Mounting way of new timer version in place of the old one

DESCRIPTION:

Old type of timer

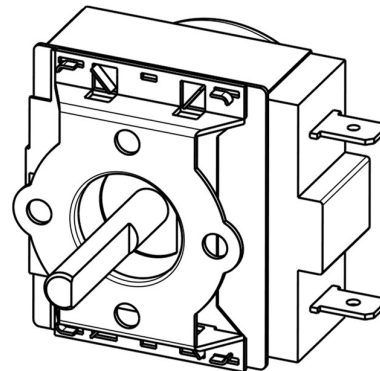
In ovens, old timer will be no longer available. New implemented timer is not fully compatible with the old one due to necessity of control panel exchange, knob exchange in some cases and reworking process of wiring additionally.
